**ADMINISTRATIVE AMENDMENT**

**FILE #** <sup>SI-2020</sup>    -00834     **PROJECT #** <sup>PR-2018</sup>    -001280

Parking calculation adjustments as shown.

MARKANA APARTMENTS - II  
SAN PEDRO AND ALAMEDA  
Albuquerque, New Mexico

A1.10

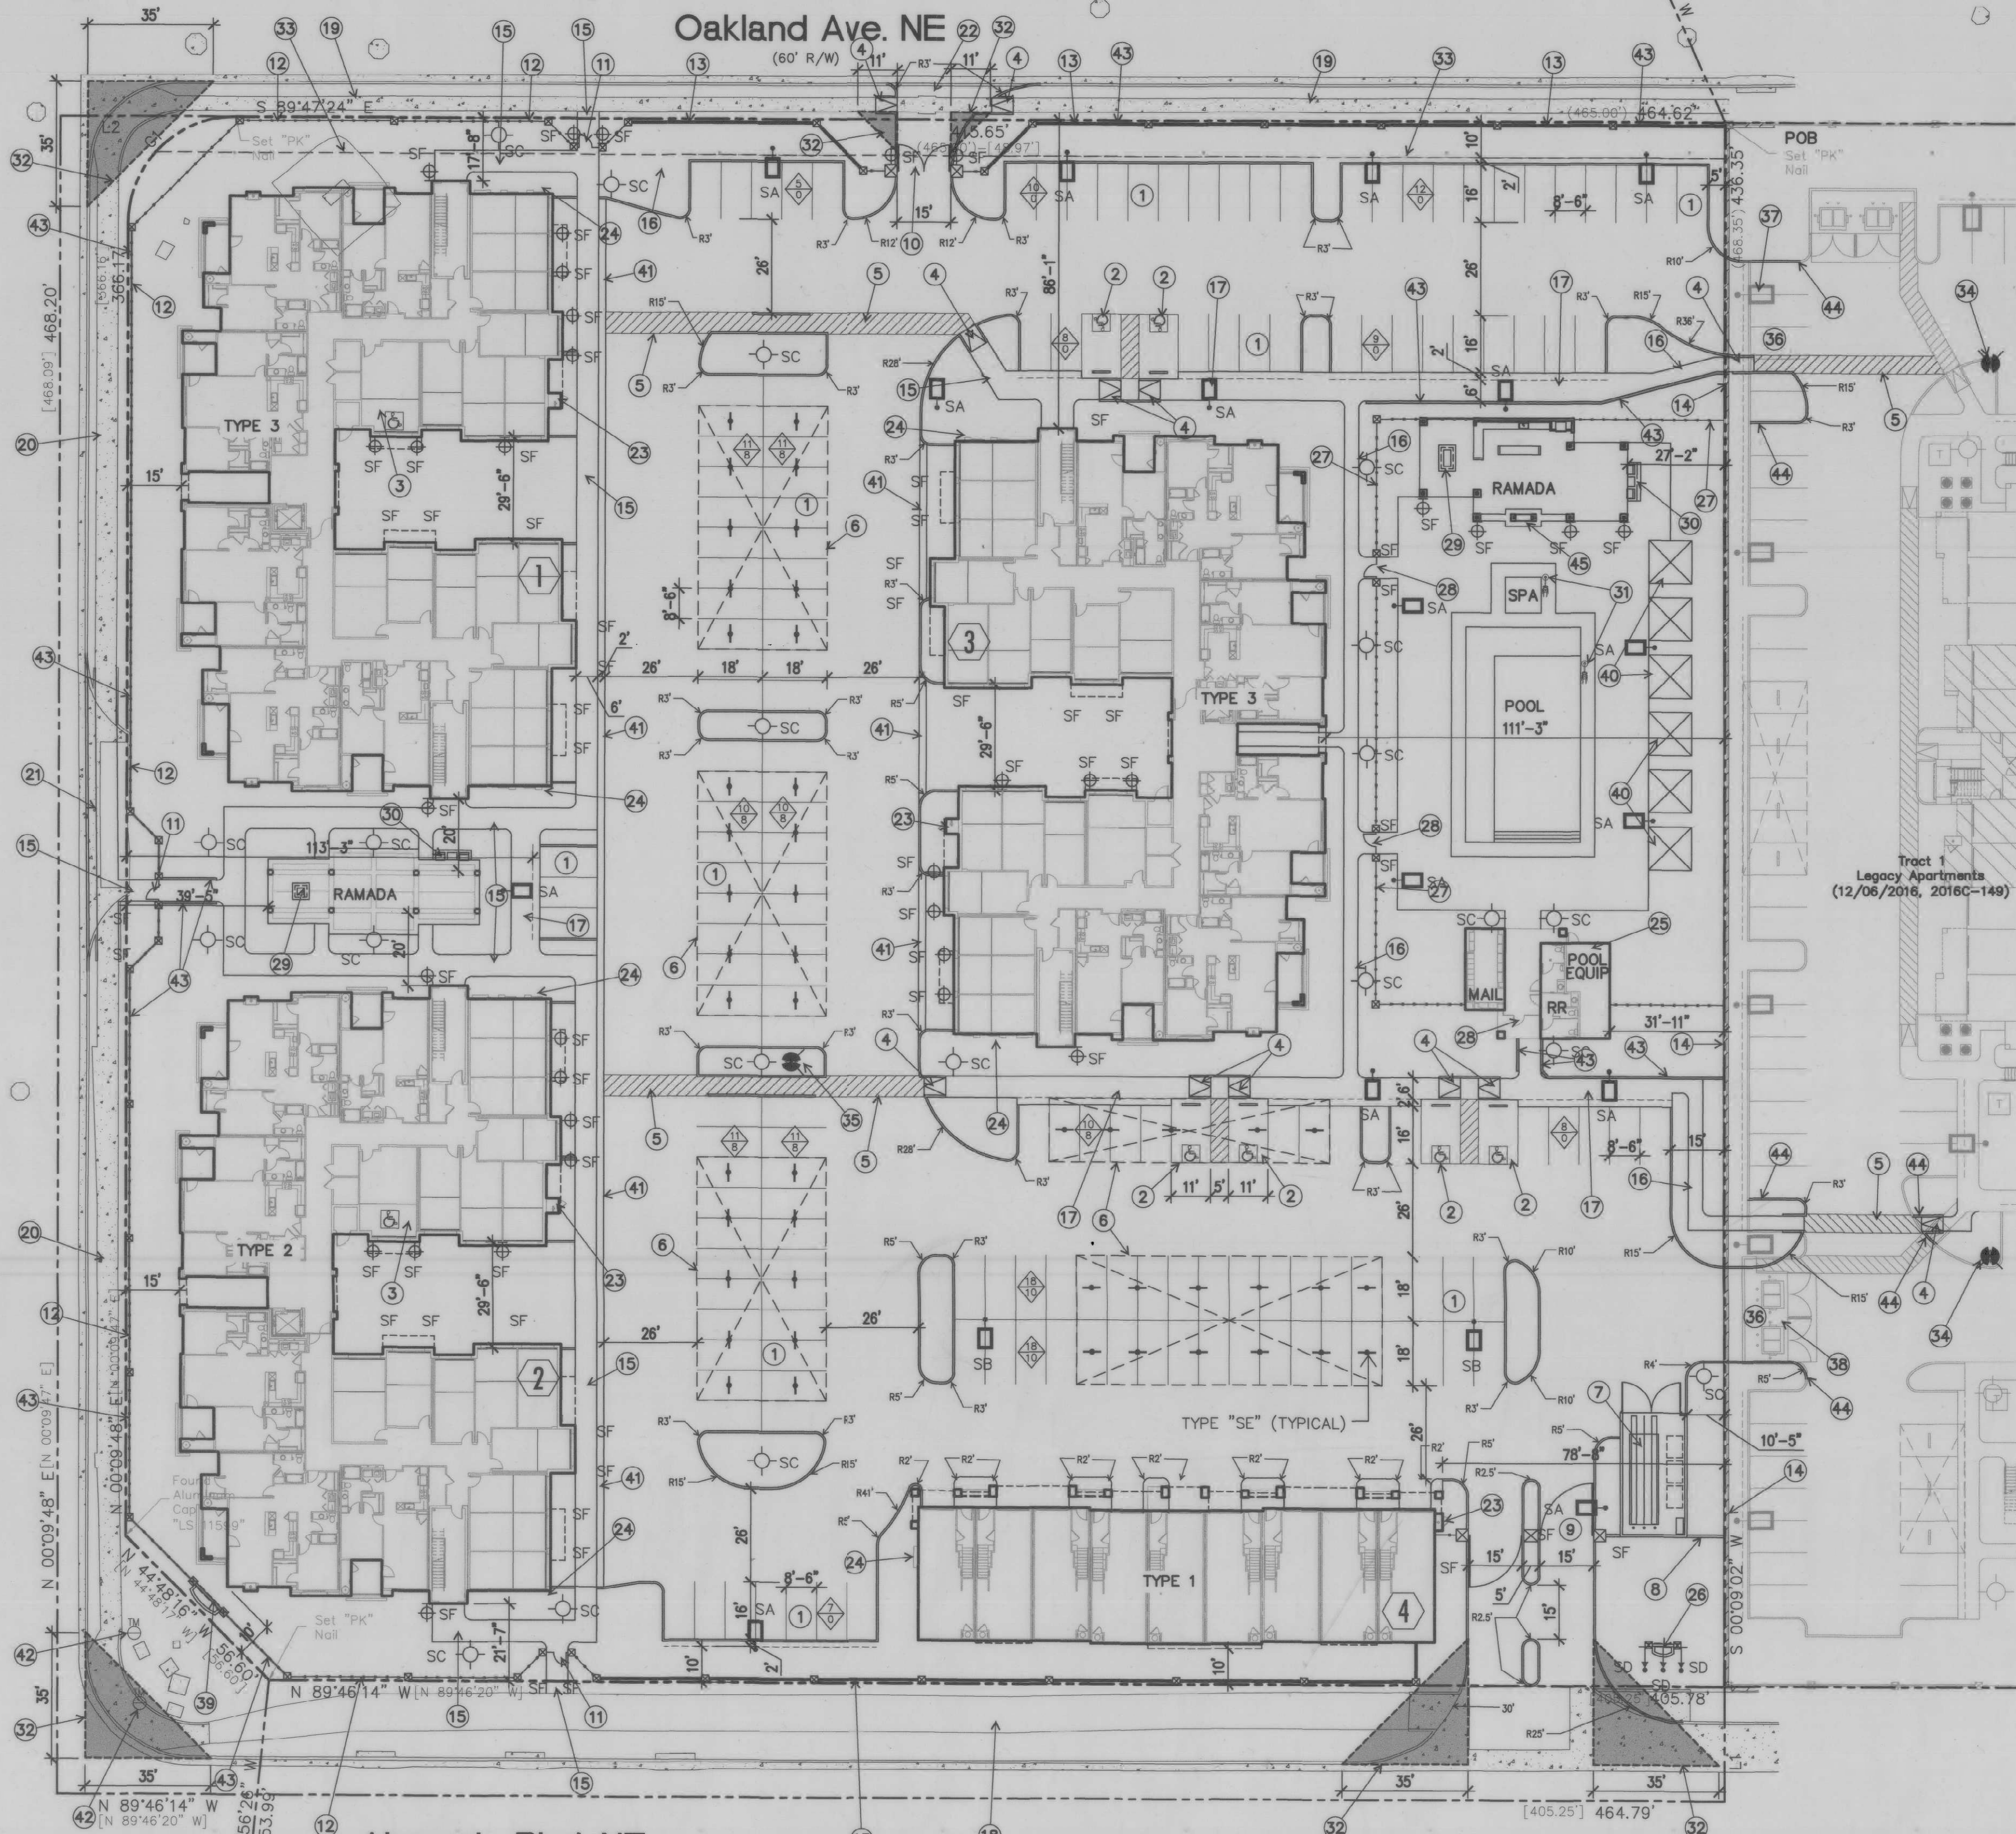
As Built - Parking Count Revised August / 19/ 2020

|  | PARKING RATIO REQUIRED | PARKING SPACES |
|--|------------------------|----------------|
| OPEN PARKING PROVIDED  |                        | 96             |
| GARAGE PARKING PROVIDED  |                        | 69             |
| Total Parking Provided   |                        | 241            |
